## ADDENDUM NO. 2

Date: January 7, 2009  
To: All Bidders and Plan Holders  
From: Abonmarche Consultants, Inc.  
Owner: Benton Harbor Area Schools  
Project: Benton Harbor High School Condensing Unit  
Project No. M8-0842

# ROOF PLAN KEYNOTES

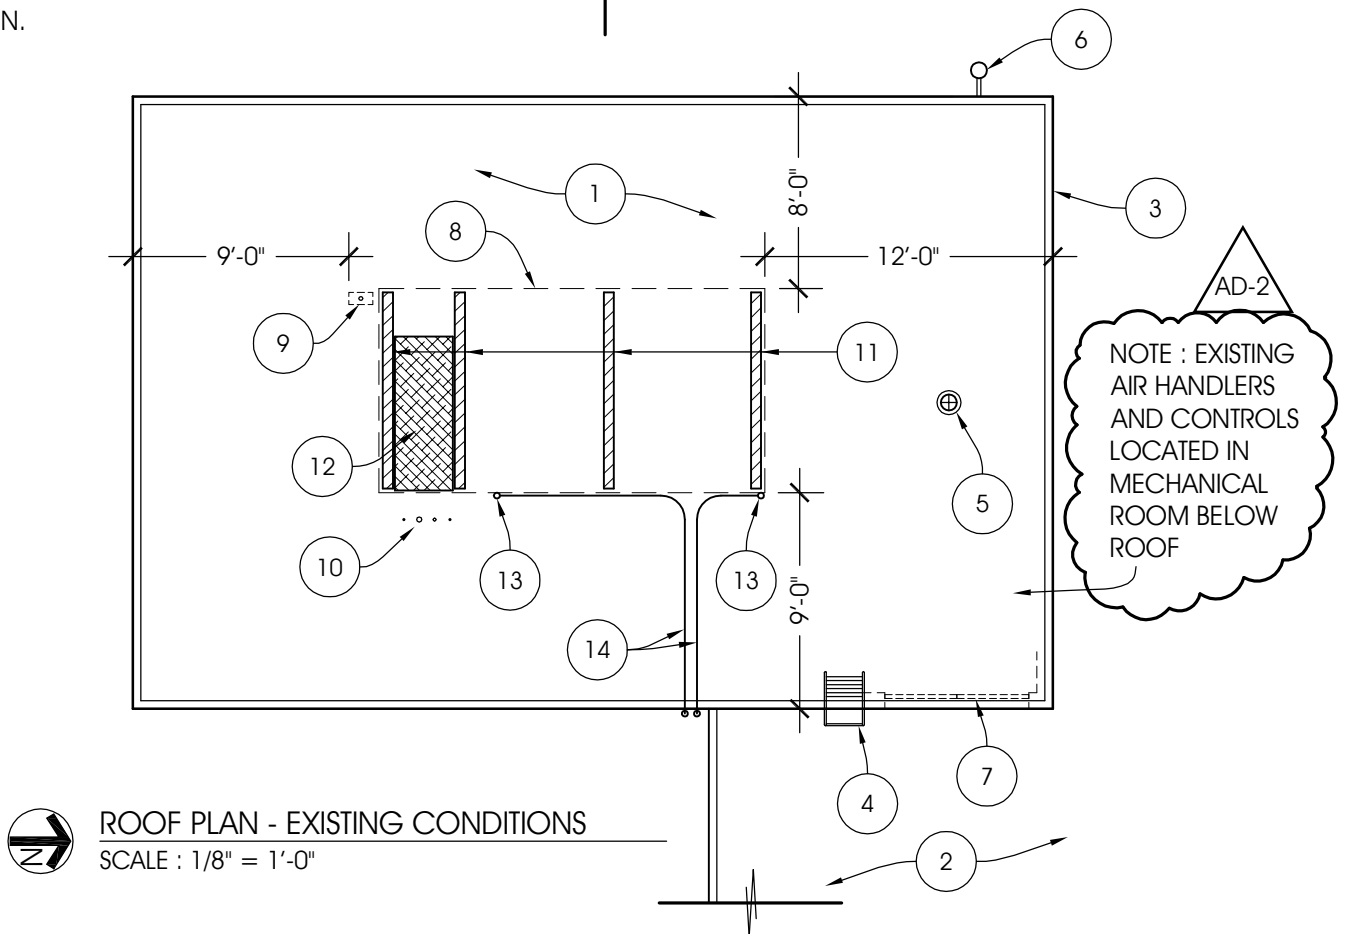
1. Refer to Sheet T1.1 – Title Sheet. Add two new sheets to Drawing Index, A1.4 – Fall Protection Plan and Sheet A1.5 – 2<sup>nd</sup> Floor Plan – identifying location of new wireless thermostats.
2. Refer to Sheet A1.1 – Roof Plan. Add notes as identified on new issued sheet AD2.1.
3. Refer to Sheet A1.2 – Curb Details. Add notes as identified on new issued sheet AD2.2.
4. Refer to Sheet A1.3 – Curb Details. Add notes as identified on new issued sheet AD2.3.
5. Add new Sheet AD2.4 – Fall Protection Plan. Furnish four steel anchoring posts attached to two steel angles field welded to existing steel bar joists in Mechanical Room below roof. Roofing Contractor to install new pitch pockets and EPDM flashings around new roof penetrations.
6. Add new Sheet AD2.5 – 2<sup>nd</sup> Floor Plan – Identifying locations of new wireless thermostats in six classrooms.

1. EXISTING ROOF AREA "S" (OUT OF WARRANTY FULLY ADHERED E.P.D.M. MEMBRANE ROOFING).
2. EXISTING LOWER ROOF "T".
3. EXISTING 4" WIDE x 4" HIGH ROOF CURB (TYP).
4. EXISTING ACCESS LADDER FROM ROOF "T" TO ROOF "S" - TO REMAIN.
5. EXISTING ROOF DRAIN TO REMAIN.
6. EXISTING SECURITY CAMERA TO REMAIN.
7. EXISTING ACCESS TO MECHANICAL ROOM BELOW ROOF "S" - PAIR OF DOORS AT LOWER ROOF.
8. OUTLINE OF EXISTING 50-TON CONDENSING UNIT TO BE DISCONNECTED AND REMOVED - SERVES A.H.U. No. 1 IN MECHANICAL ROOM BELOW ROOF "S", TO (6) INTERNAL CLASSROOMS.
9. EXISTING ELECTRICAL DISCONNECT PANEL TO REMAIN.

10. EXISTING (4) PIPE PENETRATIONS FOR COOLANT LINES BETWEEN CONDENSING UNIT ON ROOF AND A.H.U. BELOW, - TO REMAIN.
11. EXISTING FLASHED STEEL EQUIPMENT CURBS TO REMAIN - SEE REVISED CURB DETAILS ON SHEET A1.2.
12. INSPECT EXISTING ROOFING IN THIS AREA WHEN EXISTING CONDENSER IS REMOVED. EXISTING ROOFING MEMBRANE IS LAID ON SURFACE, AND IS NOT ATTACHED VIA ADHESIVE OR MECHANICAL MEANS, - RE-ATTACH AS REQUIRED.
13. EXISTING AERIALS FASTENED TO EXISTING CONDENSER - TO BE TEMPORARILY REMOVED AND REINSTALLED ON NEW CONDENSING UNIT.
14. EXISTING AERIAL CABLES TO REMAIN, - REVISE LENGTHS AS NECESSARY TO ACCOMMODATE NEW LOCATIONS OF AERIALS. VERIFY THAT ALL SYSTEMS ARE FUNCTIONING PROPERLY UPON COMPLETION OF WORK.

CONDENSING UNIT CURB - DETAIL "A"  
SCALE : 1-1/2" = 1'-0"

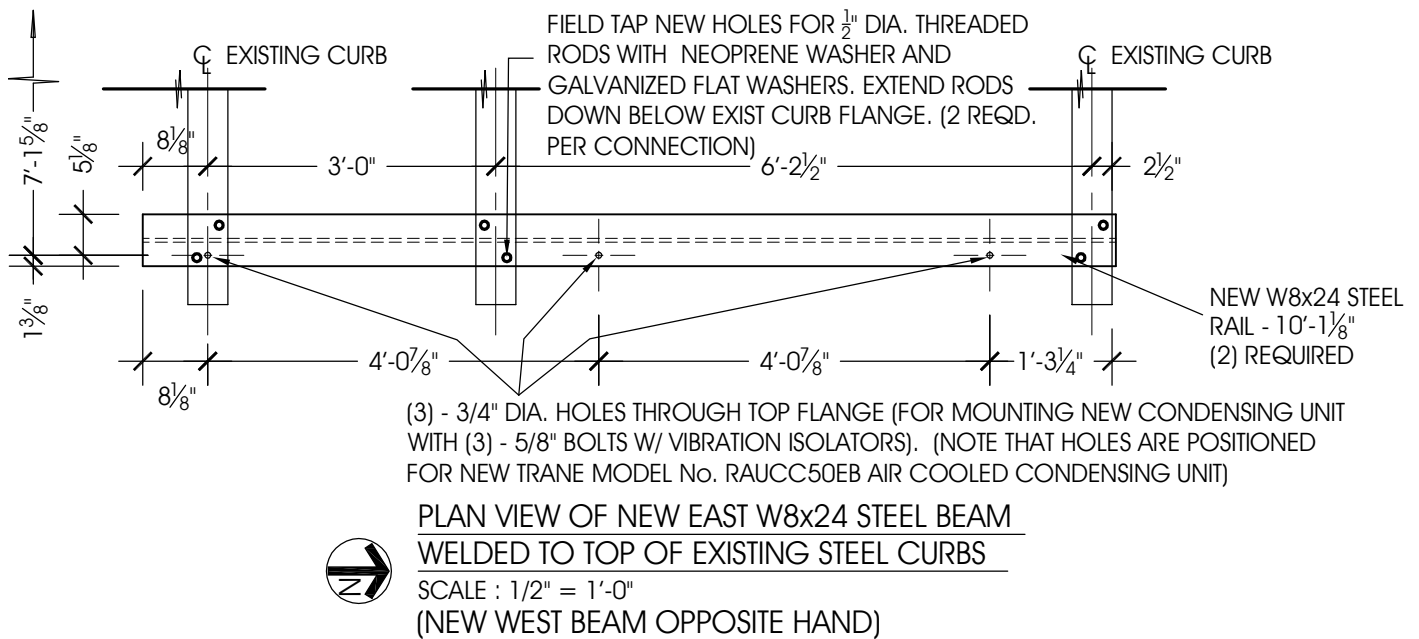
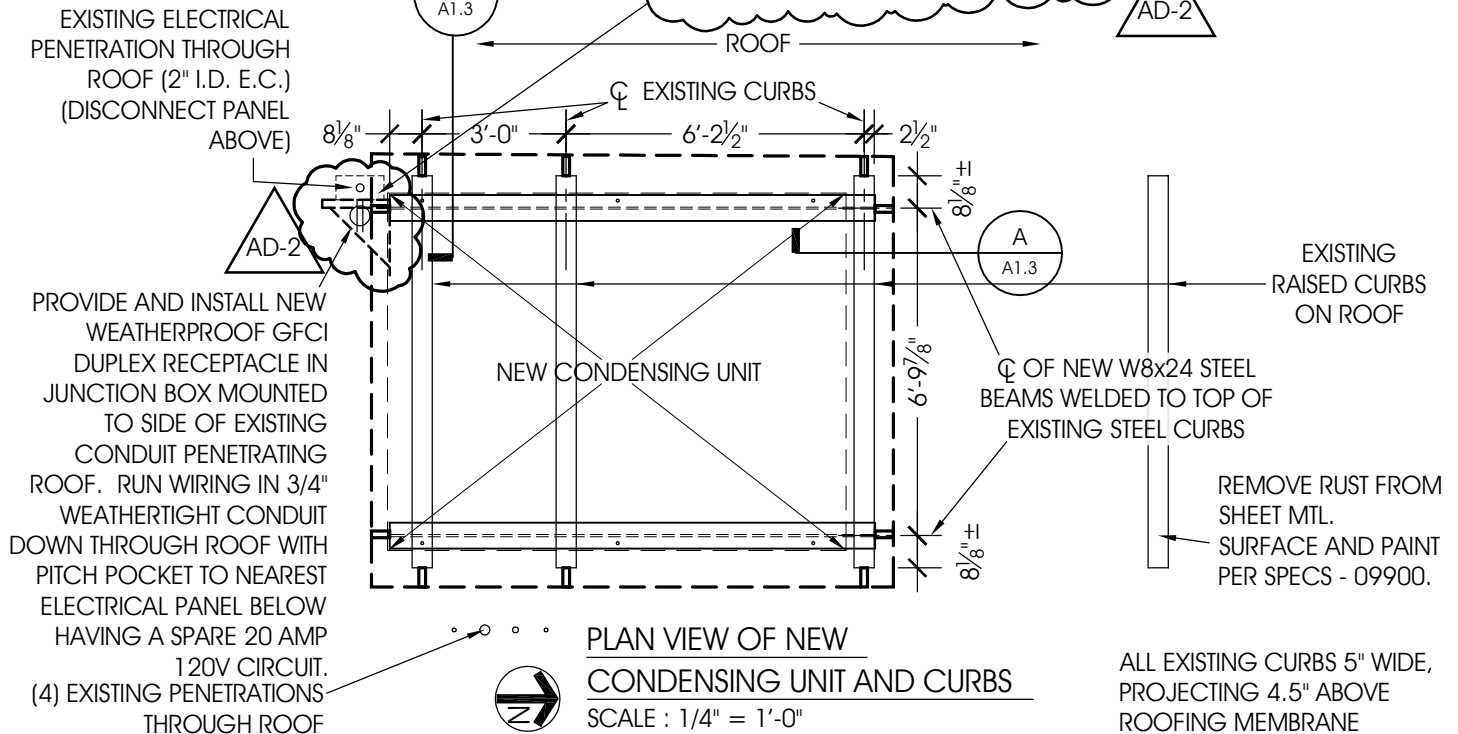
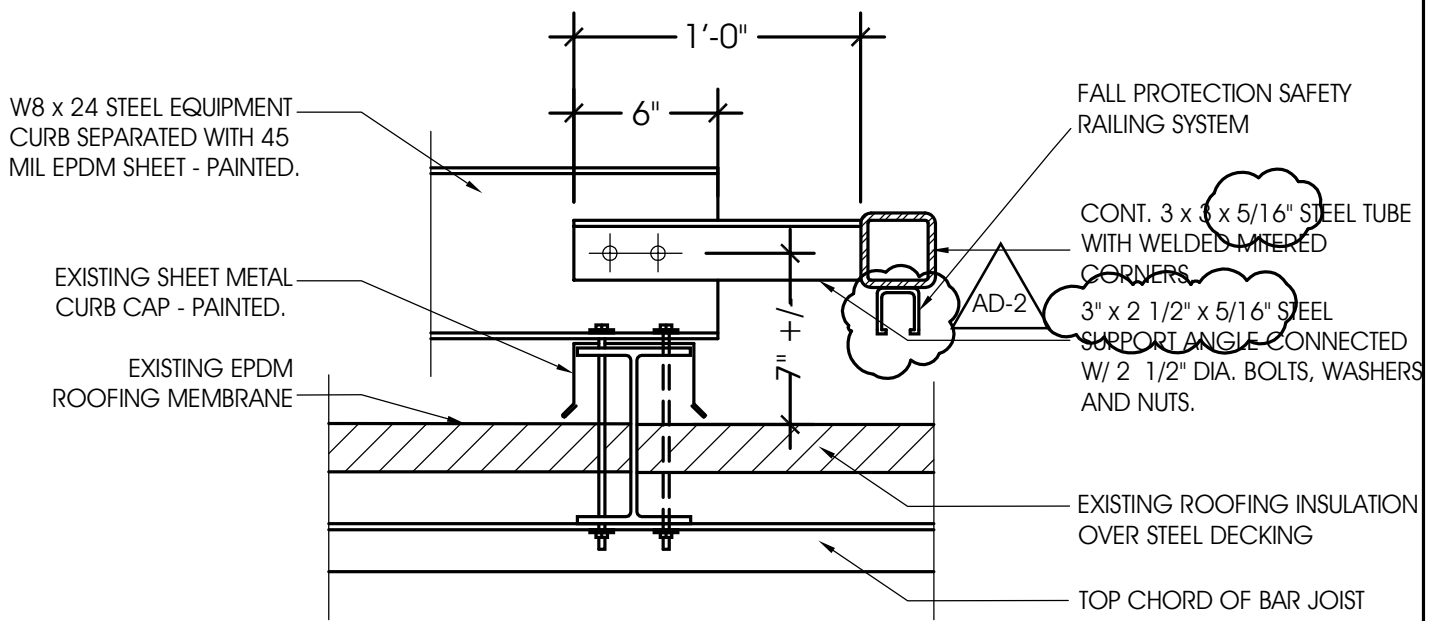
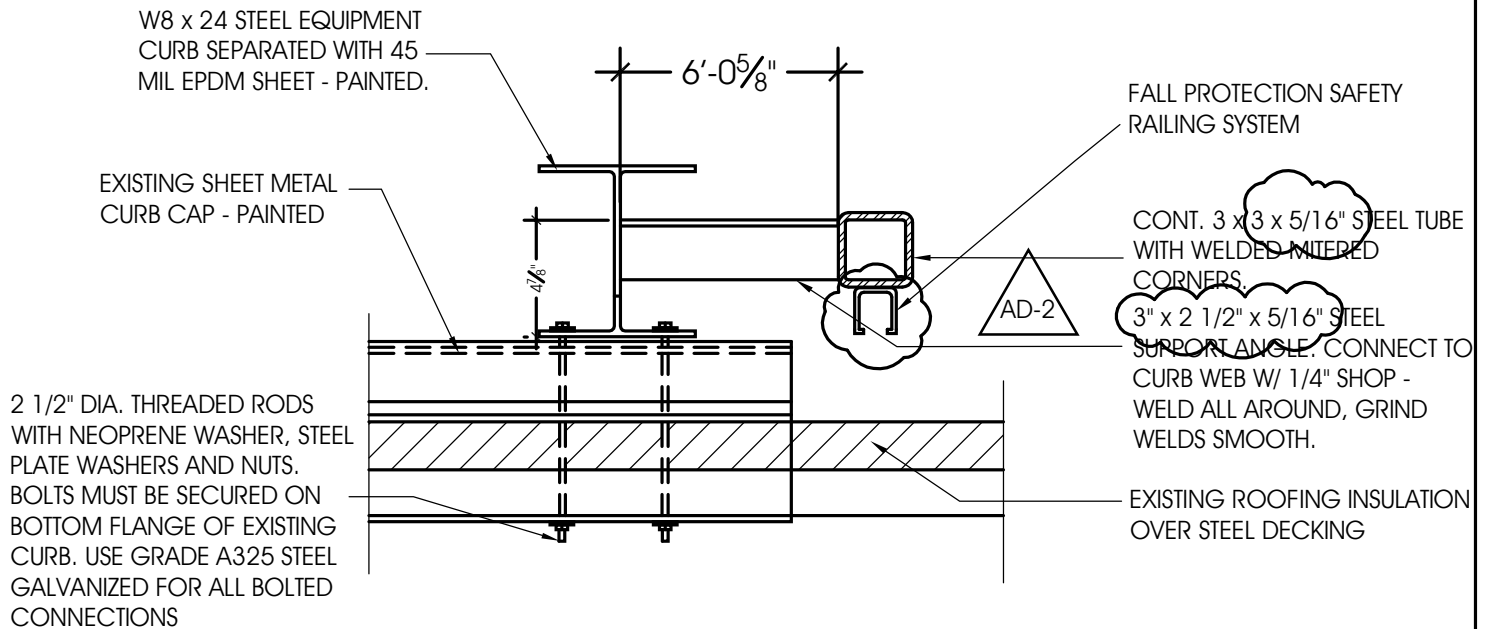
NOTE: EXISTING FLASHING OVER EQUIPMENT CURBS TO REMAIN. INSTALL A 45 MIL EPDM SEPARATOR SHEET BETWEEN THE FLASHING AND BOTTOM OF NEW EQUIPMENT CURB STEEL. ATTACH NEW CURB STEEL WITH  $\frac{1}{2}$ " DIA. THREADED RODS. SEAL JUNCTURE WHERE NEW CURB MEETS THE EXISTING CURB WITH POLYURETHANE SEALANT - TYPICAL AT ALL INTERSECTIONS.

ROOFING CONTRACTOR TO CUT IN A NEW 4" SQ. X 4" HIGH PITCH POCKET INTO EXIST. ROOF FIELD MEMBRANE. FLASH IN NEW EPDM FLASHING PER NRCA STANDARDS. FILL POCKET WITH CONCRETE BASE AND PITCH MATERIAL, THEN CAP WITH SELF-LEVEL URETHANE SEALANT.

REINSTALL EXISTING DISCONNECT PANEL SUPPORT TO NEW CONDENSING UNIT. PAINT SURFACES BEFORE MOUNTING DISCONNECT PANEL

PARTIAL EXISTING 2ND FLOOR PLAN  
ROOM THERMOSTAT LOCATIONS  
SCALE : 1/32" = 1'-0"

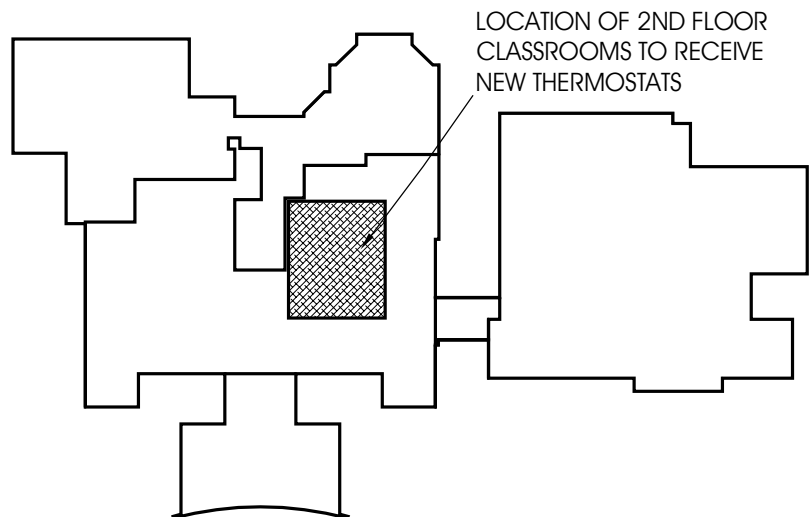
1. FIELD LOCATE (6) NEW WIRELESS THERMOSTATS IN CLASSROOMS AS SHOWN.
